DOE/EIS-0089

ADDENDUM TO ENVIRONMENTAL IMPACT STATEMENT

Operation of PUREX and Uranium Oxide Plant Facilities

Hanford Site
Richland, Washington

FIGURE 3.1. PUREX/UO₃ Facilities and Other Hanford Facilities

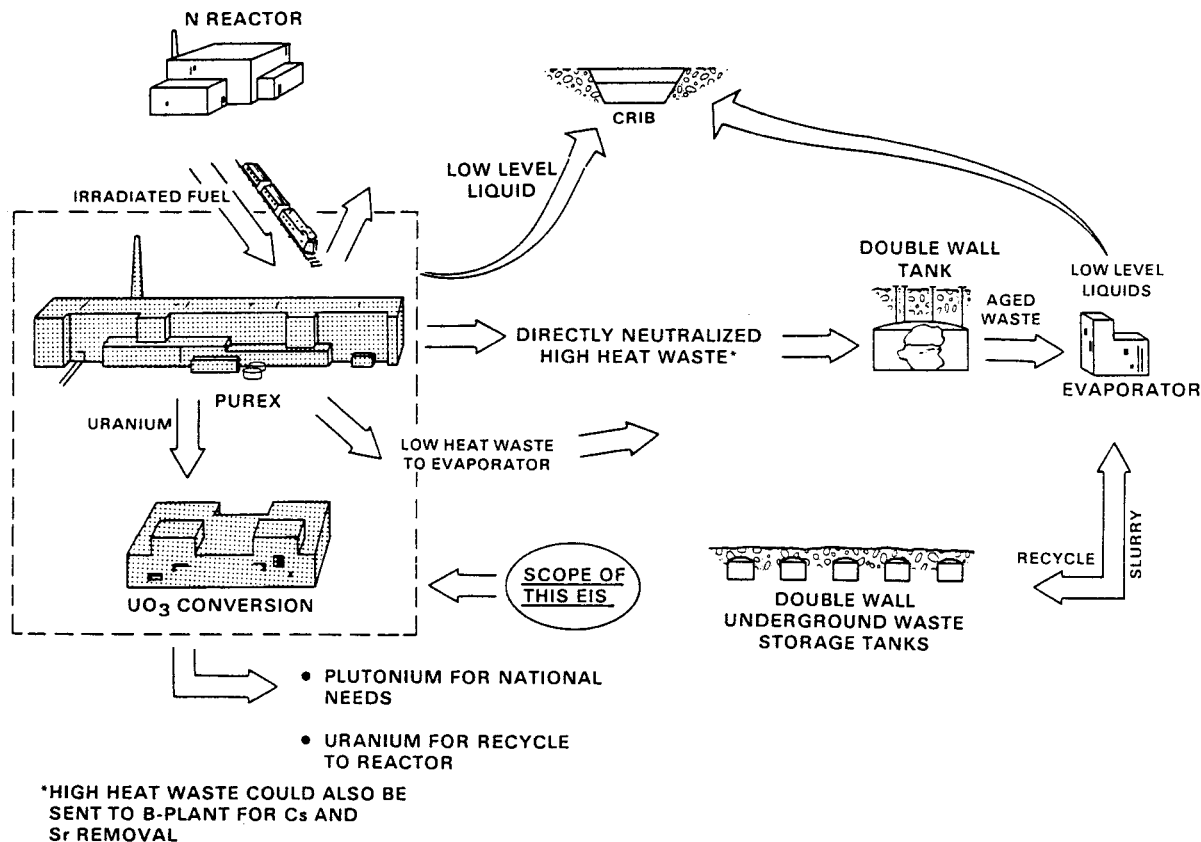
Replace Figure 3.1 with the Figure shown below.

Reason: Factual correction.

FIGURE A.3. Uranium Final Cycle Process Flow Diagram

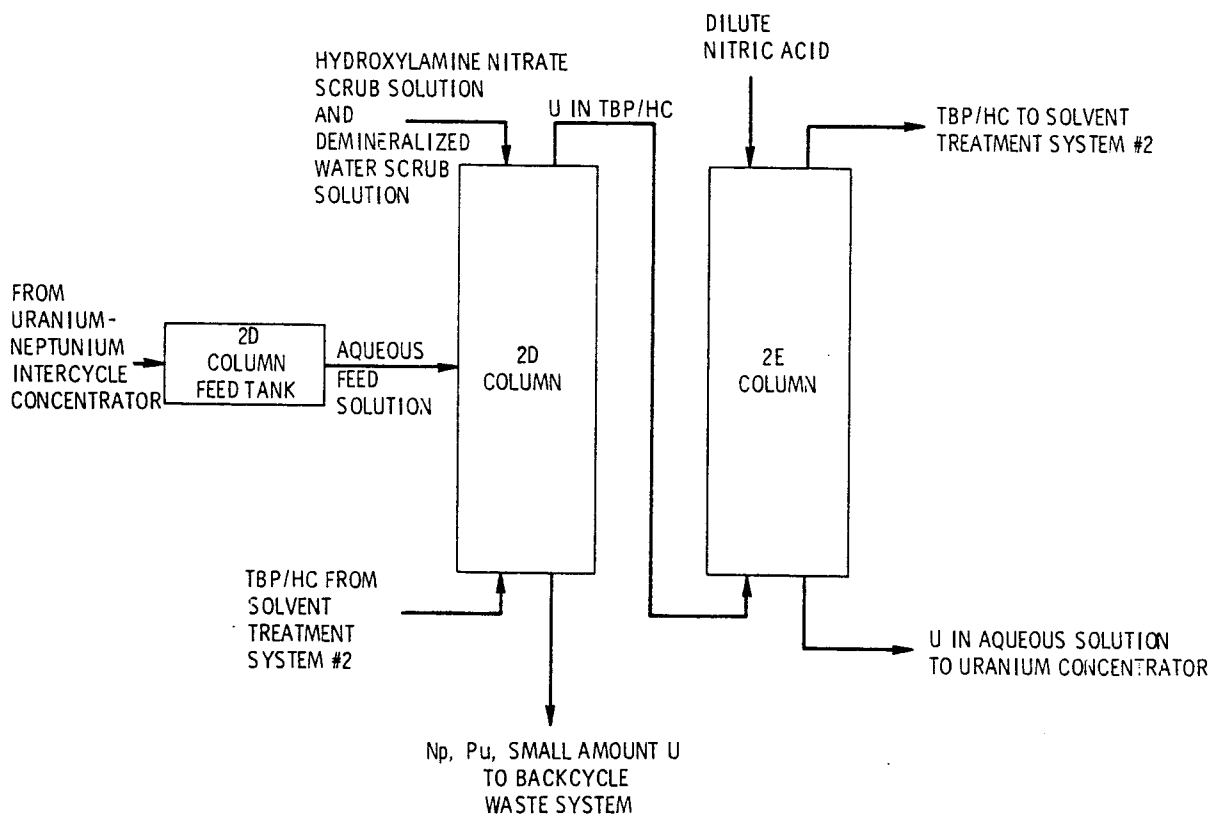
Replace Figure A.3 with the figure shown below.

Reason: Factual correction.
